PROJECT TITLE: Prairie Dog Ridge ZONE ATLAS/DRNG. FILE #: G-23/D2B1

RE: DRAINAGE REPORT FOR PRAIRIE DOG RIDGE (G-23/D2B1)
ENGINEER'S STAMP DATED JUNE 2, 1992

RE: DRAINAGE REPORT FOR PRAIRIE DOG RIDGE, RECEIVED APRIL 14, 1992 FOR PRELIMINARY PLAT AND ROUGH GRADING PERMIT APPROVAL, (G-23/D2B1)

RE: DRAINAGE REPORT FOR PRAIRIE DOG RIDGE (G-23/D2B1)
ENGINEER'S STAMP DATED JANUARY 6, 1993

TITLE PRAIRIE DOG RIDGE SUBDIVISION
GRADING PLAN

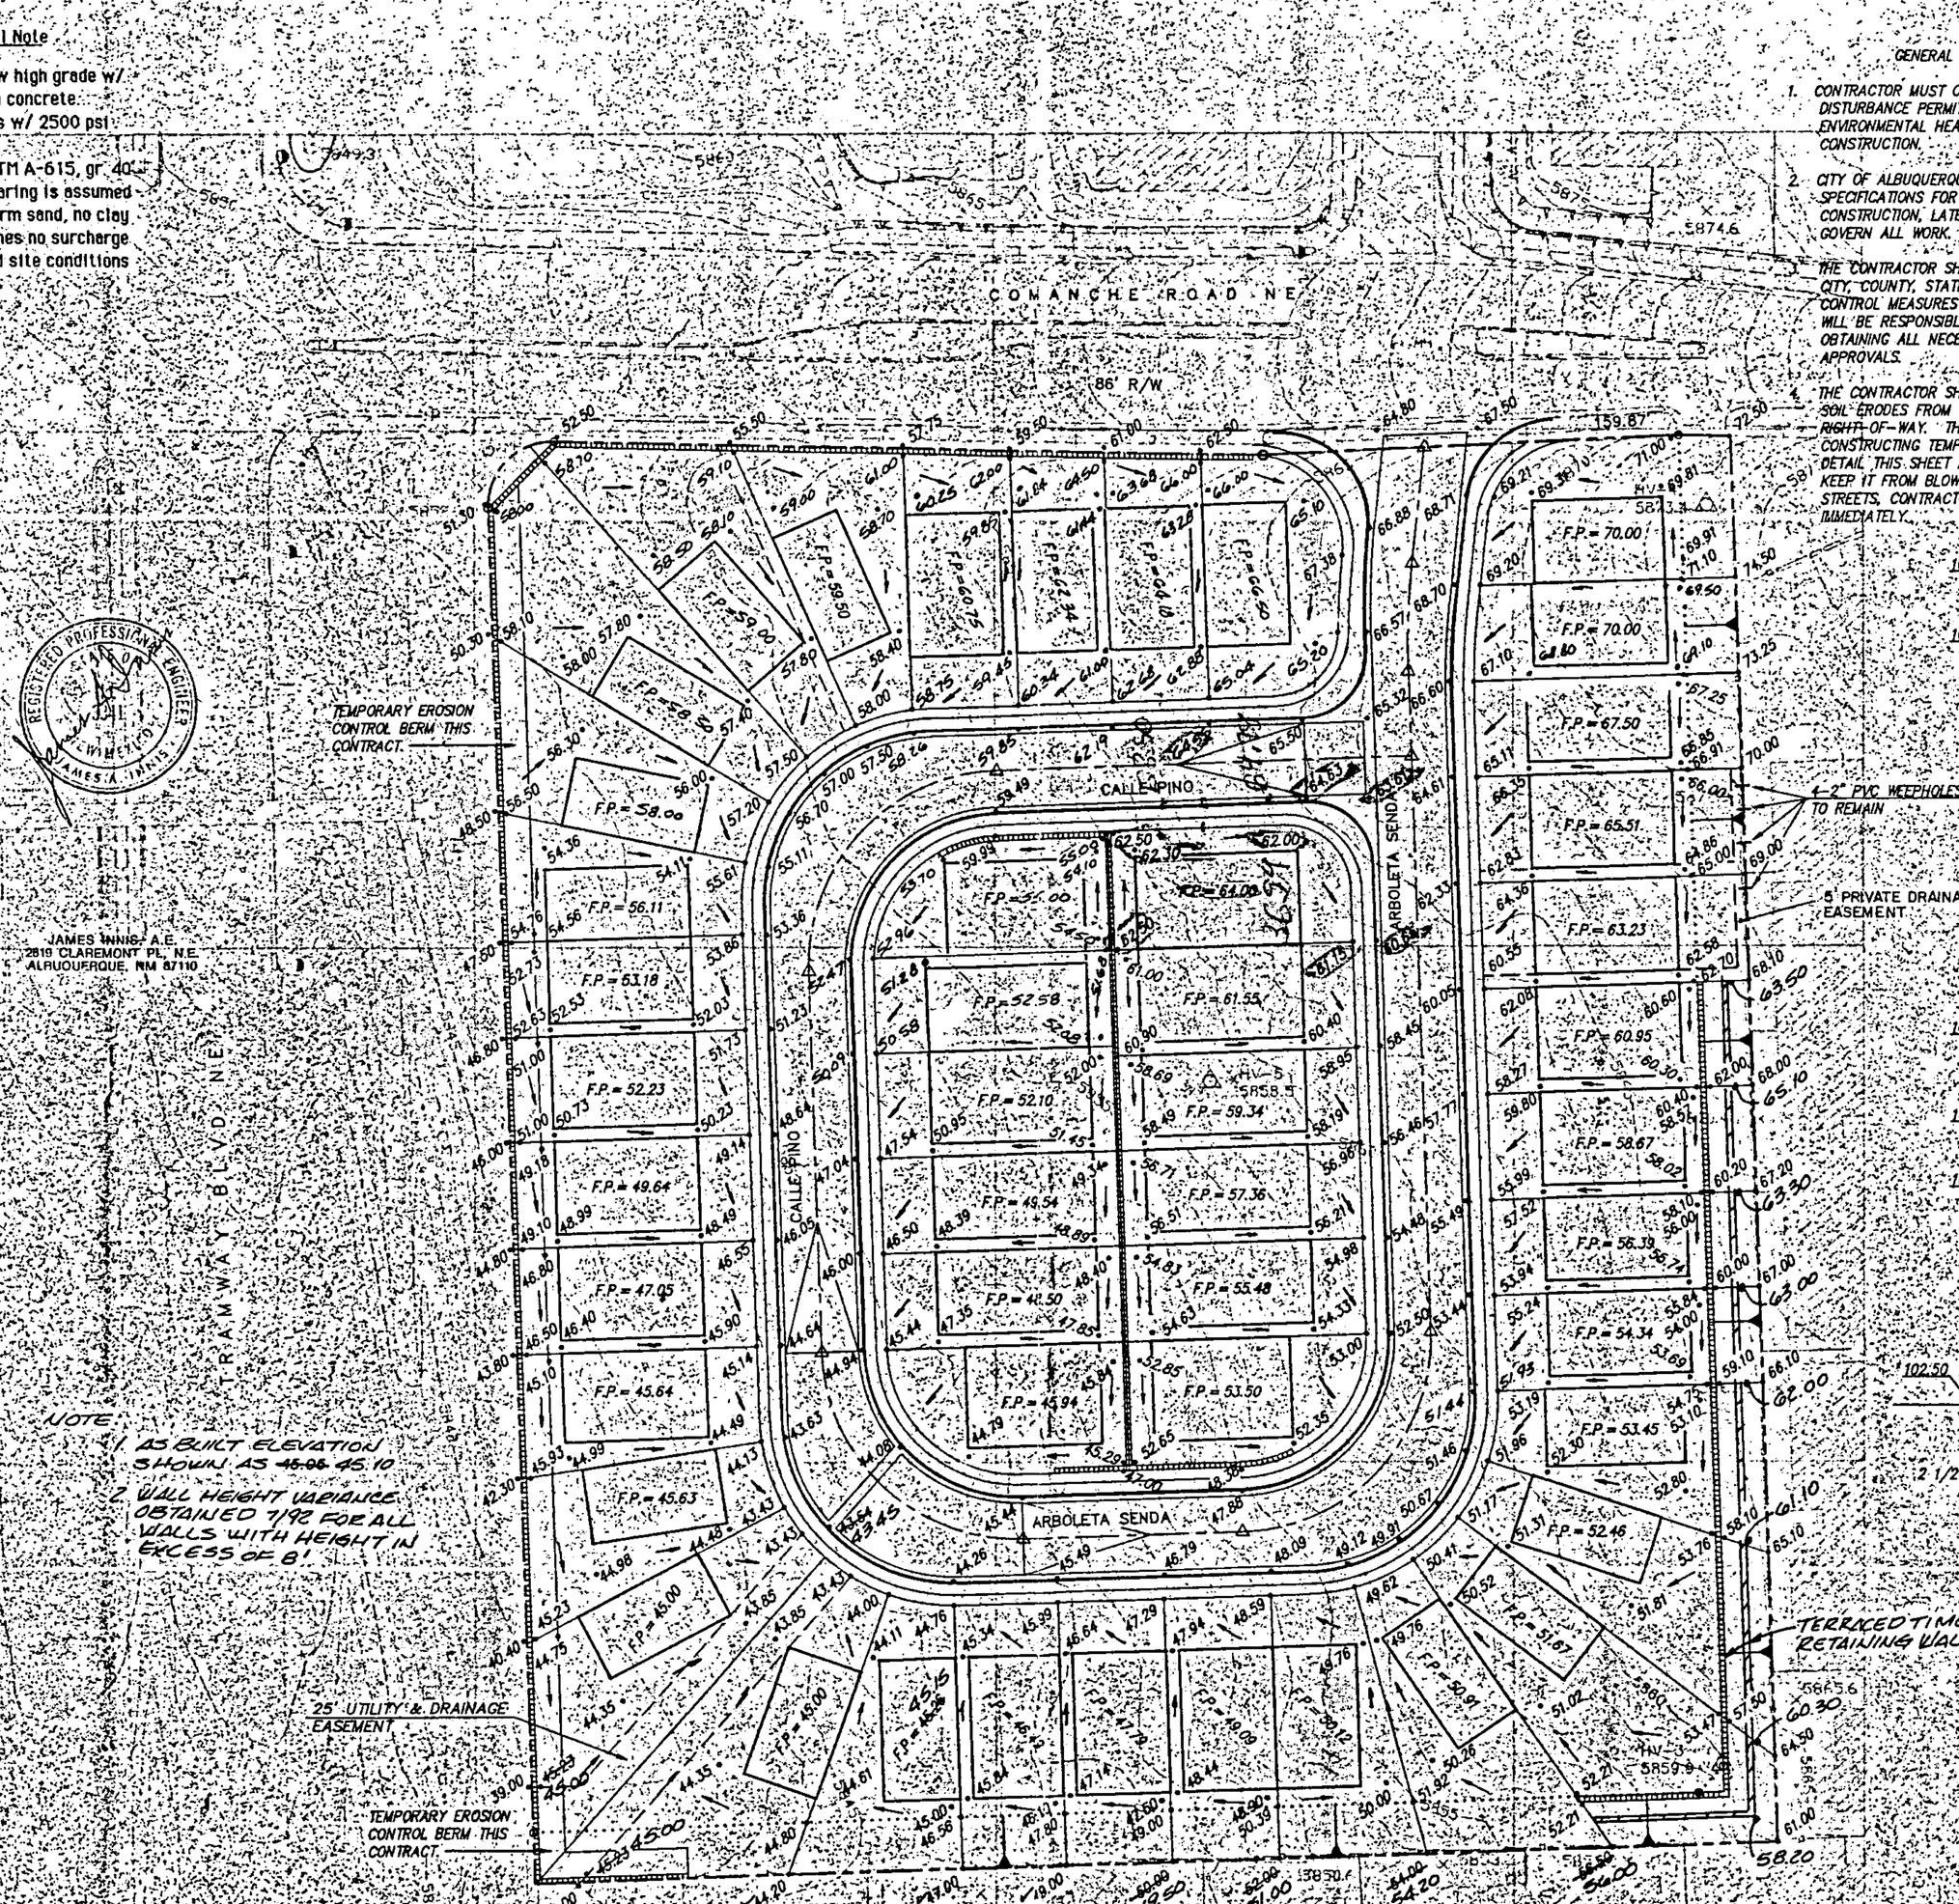
1. Building Pad Envelopes and finish floor elevations need to be shown.

2. How will the rear yard drainage get to the street? Are you proposing side yard swales? All roof drainage will need to be directed to the street.

3. Sheet 3 of 3 identifies a 6 inch curb, Standard Curb and Gutter is 8 inches?

4. Please provide additional spot elevations imediately outside of the property line.

5. The storm drain easement should encumber only one property owner.

Attached, please find a revised Grading Plan and supporting calculations for the referenced project. We offer the following:

- Building pads and elevations have been defined as requested.
- Rear yards will drain to the street via side yard swales. Roofs will also drain to street.
- We acknowledge that standard curb and gutter is 8" high.
- Spot elevations outside of boundary at every lot corner have been provided.
- The easement is also a utility easement and has been coordinated at DRB.

APPROVED w/ Condition std C&G from PC to PT @ SE Corner of Subdivision. The [illegible]ding is based on securing a zoning variance otherwise contractor will need to regrade site

CALLE P

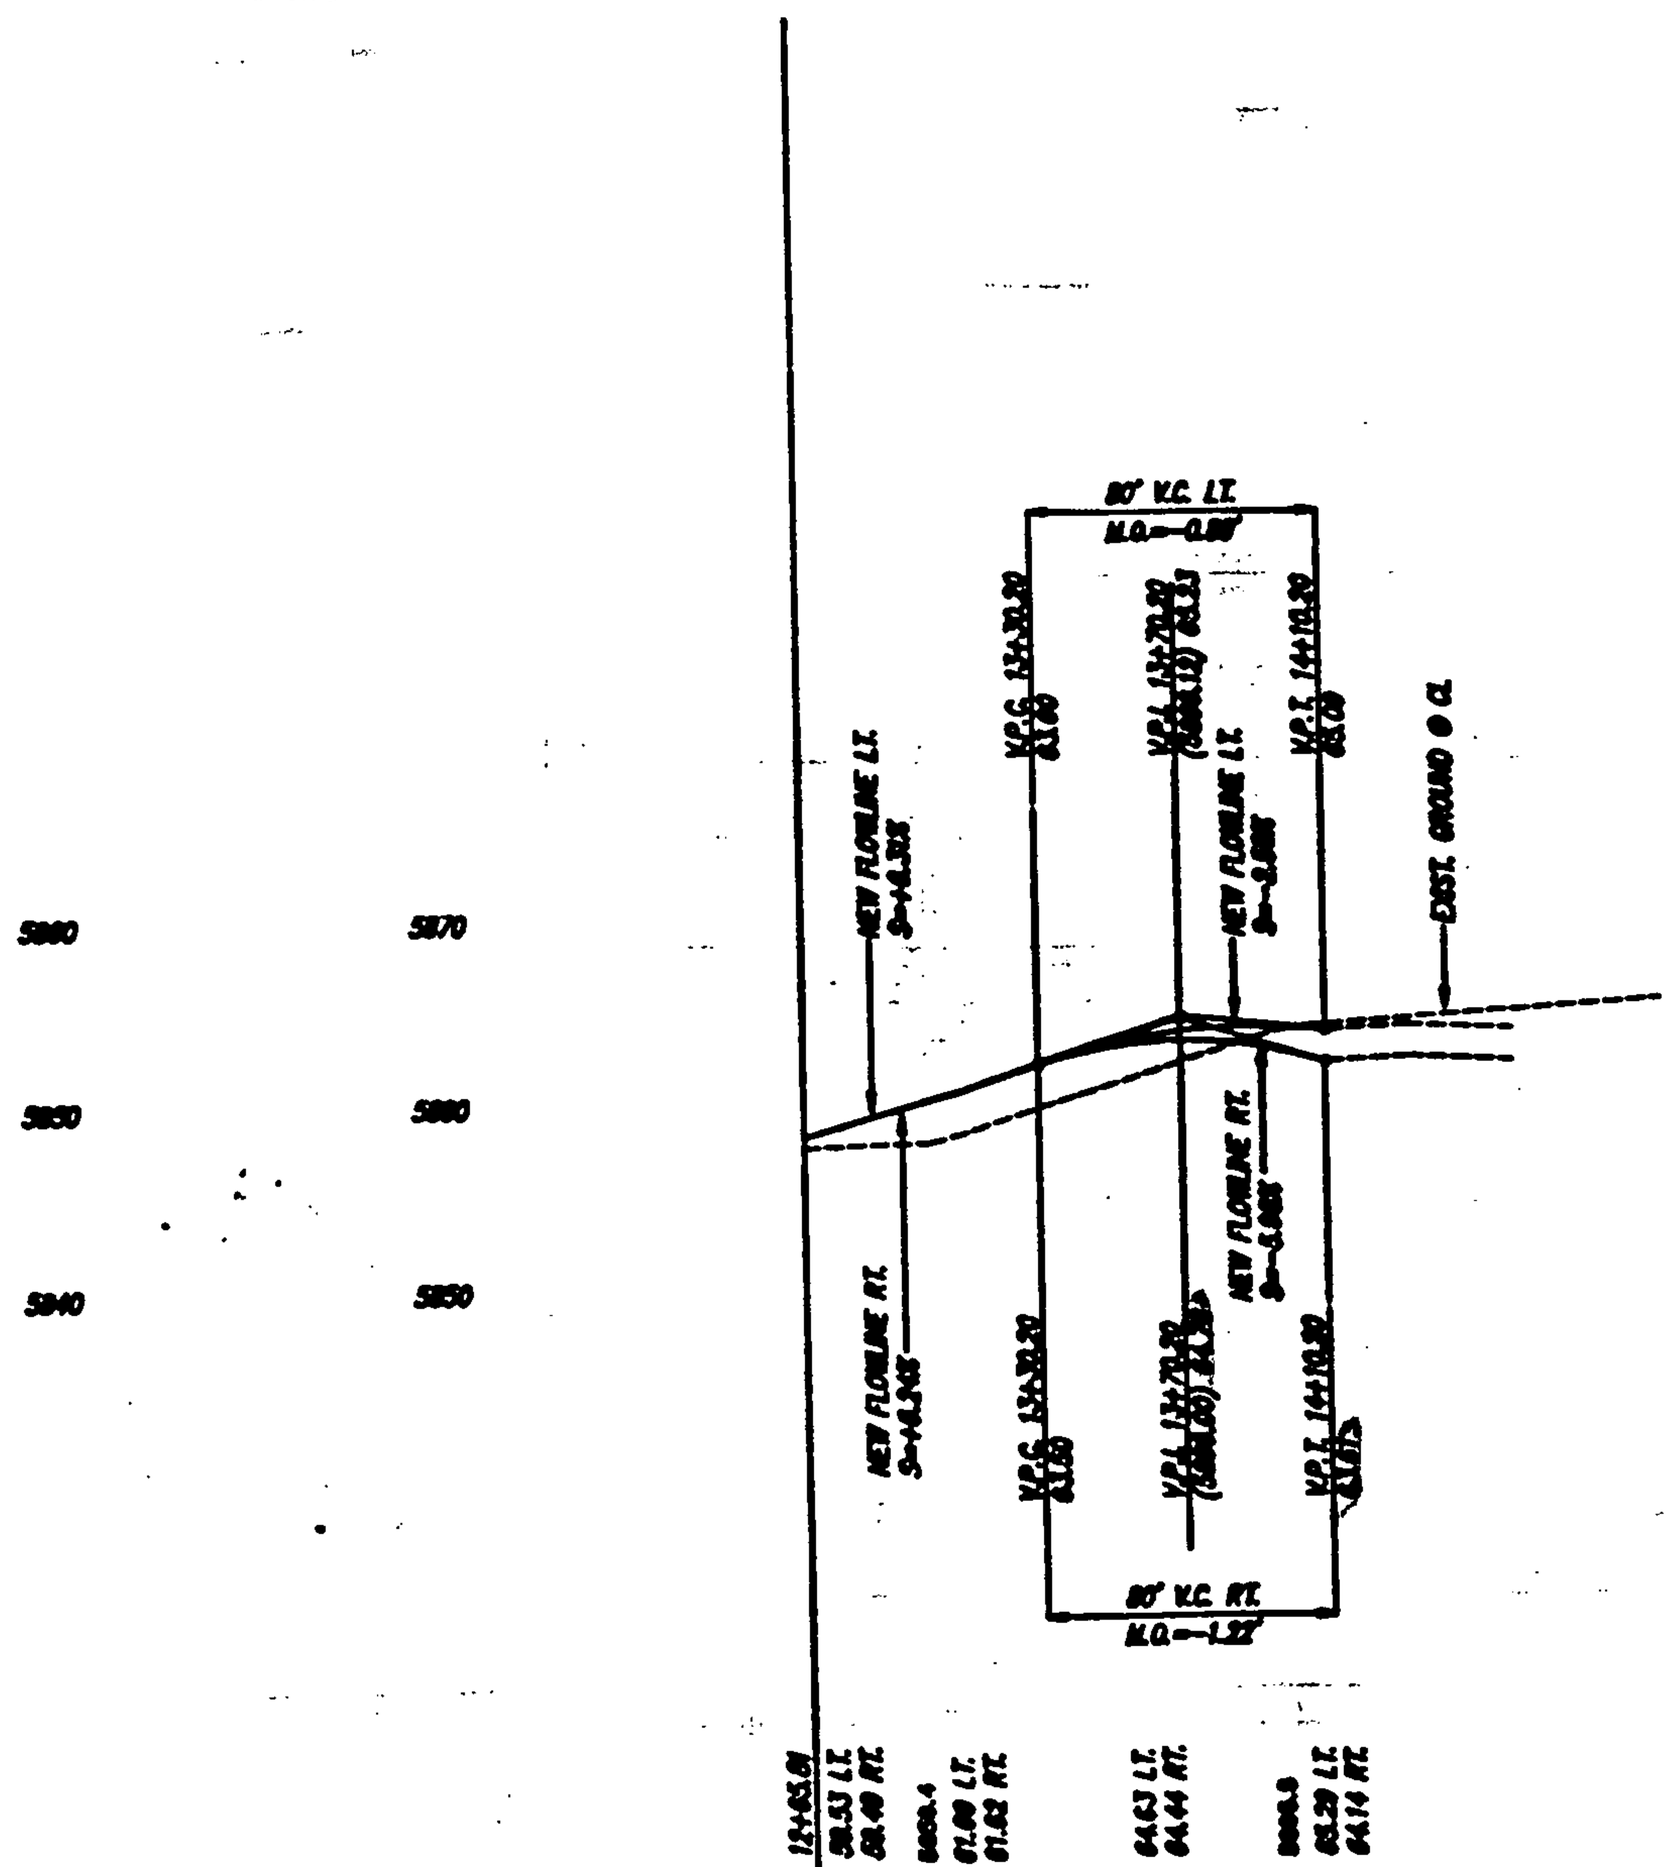
Vertical curve in Calle Pino raises the street about 2ft. above side yard swale.

1. Developed run-off is not routed according to the approved drainage plan certified by Mark Goodwin. The plan routes the run-off from the backyard to Arboleta Senda in front. Currently there is a ridge at the middle of the lot that forces the run-off from the backyard into the neighboring lot to the west.

2. The side lot swale does not appear to have been graded. The owner has installed a perforated pipe drain on the north side of the house to prevent run-off from the side lot from entering the house.

Comparison of the drainage plan to the profile for Calle Pino indicates that the back of sidewalk should be approximately three feet higher than the flowline of the side lot swale at the V.P.I. This may have encouraged the creation of the ridge. Attached is a copy of the approved drainage plan and a copy of the profile for Calle Pino. I have highlighted the elevations that I believe are important to this complaint.
